## DEVELOPMENT APPLICATION ASSESSMENT REPORT

<b>Application Number:</b>	DA2021/1755
----------------------------	-------------

<b>Responsible Officer:</b>	Brittany Harrison
<b>Land to be developed (Address):</b>	Lot 2 DP 1014283, 152 Headland Road NORTH CURL CURL NSW 2099
<b>Proposed Development:</b>	Alterations and additions to a dwelling house including a garage, swimming pool and spa
<b>Zoning:</b>	Warringah LEP2011 - Land zoned R2 Low Density Residential
<b>Development Permissible:</b>	Yes
<b>Existing Use Rights:</b>	No
<b>Consent Authority:</b>	Northern Beaches Council
<b>Land and Environment Court Action:</b>	No
<b>Owner:</b>	Melissa Ann Rowlands Luke Simon Rowlands
<b>Applicant:</b>	Signature Design & Drafting

**(Figure 1: Western Elevation - Red Shading to indicate Building Height Non-Compliance of Proposed Development)**

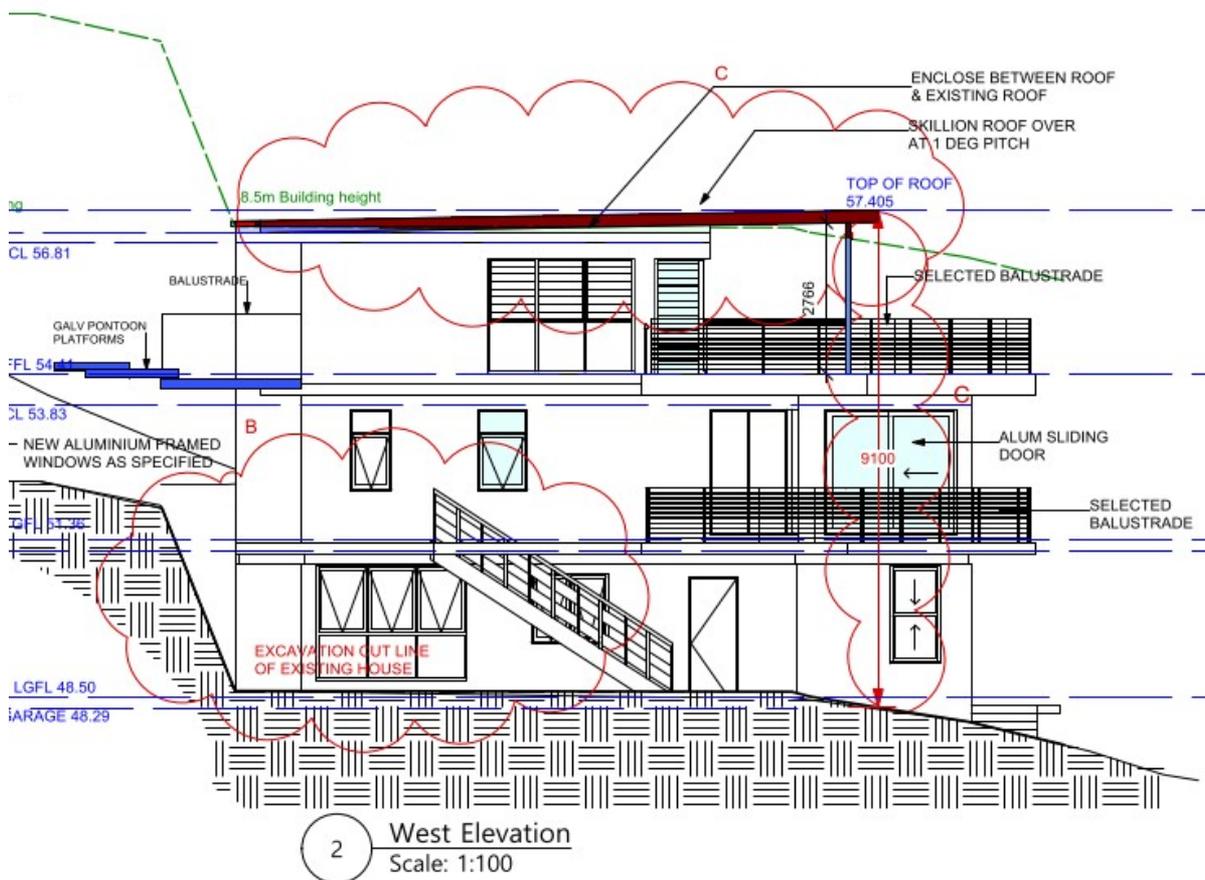
Development standard:	Height of buildings
Requirement:	8.5m
Proposed:	9.322m
Percentage variation to requirement:	9.67%

- The Building Height variation is justified on the basis that the non-compliance is restricted to the western portion of the building, predominantly caused by the proposed pergola and skillion roof design.
- The variation is consistent with the surrounding properties that have substantial height and similar bulk and scale to the subject site and is compatible with the 2-3 storey character dominating Headland Road. With the non-compliance being imperceptible when viewed from the public domain and adjoining properties.
- With the existing location of the subject and adjacent dwellings enjoying an elevated position, impacts to view corridors and visual privacy have been minimised, the proposal also presents compliance with the solar access requirements.
- The result of the numerical non-compliance is predominantly caused by the steep sloping

The proposed pergola and reconstructed roof form exhibits a height of RL 57.405 at its highest point. The adjoining western property presents a ridgeline of approximately RL 60.18, with the eastern adjoining property obtaining an approval for a dwelling house with a height of RL 55.467. Therefore, the proposal demonstrates consistency in way of design and spatial proportions with the properties within the immediate vicinity, maintaining an acceptable height and scale when compared to the existing 2-3 storey streetscape character.

Amended plans were received during the course of assessment which reduced the overall building height variation by amending the roof design and roof pitch, aiding in the mitigation of potential view loss impact to adjoining neighbours. In addition, a condition of consent has been recommended to increase the side setbacks of the proposed pergola to provide visual relief and open up the existing view corridor to the western neighbour No. 154 Headland Road. Privacy impacts in relation to the building height variation will remain as existing and will not further impact the adjoining neighbours, as no extension to the balcony is being proposed. Acceptable solar access has been provided to the open space areas of the adjoining properties, receiving the minimum requirement of access to sunlight.

(Figure 1: Side Building Envelope Encroachment to Western Elevation - Red Proposed Encroachment, Yellow Existing Encroachment)

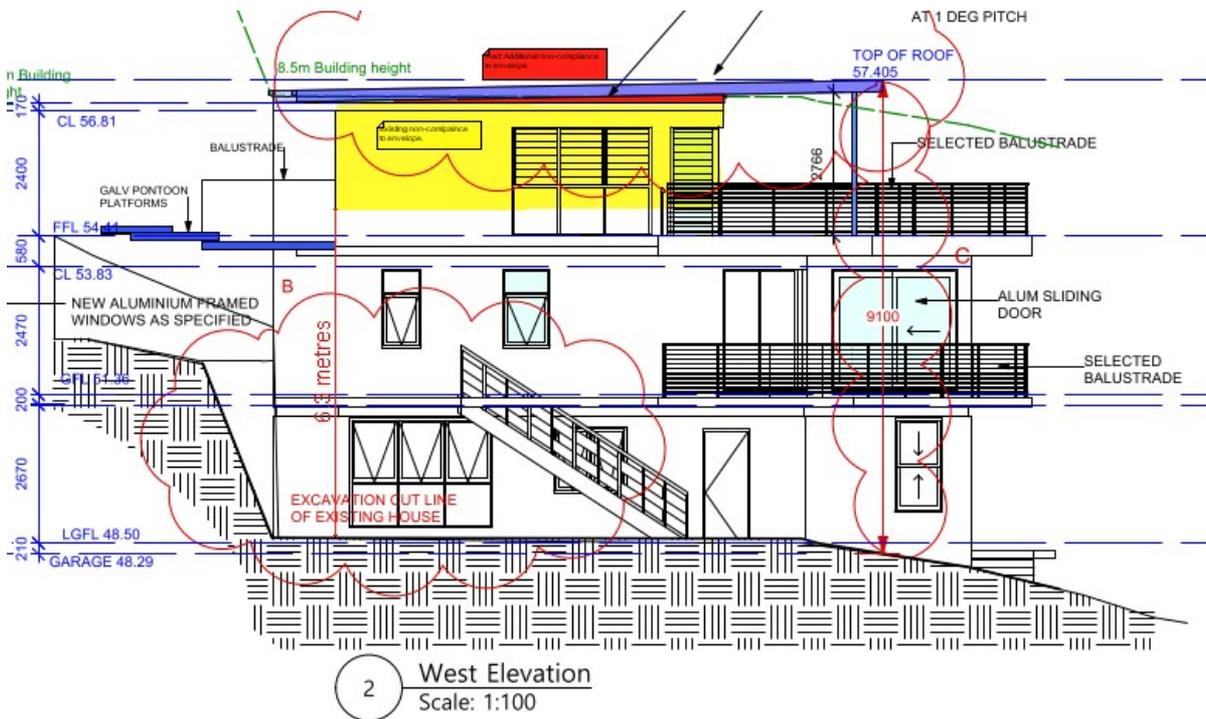
Note: The existing dwelling house, also presents numerical non-compliance to the requirements to the side boundary envelope along the western elevation and is shown in yellow in the figures below. The assessment will only refer to the additional side boundary envelope encroachments.

The encroachment to the side boundary envelope to both the eastern and western elevations does not impact on the level of required solar access, as per *Clause D6 Access to Sunlight*. Privacy is considered to be acceptable within a residential environment and is addressed in further detail within *Clause D8 Privacy* elsewhere within this report.
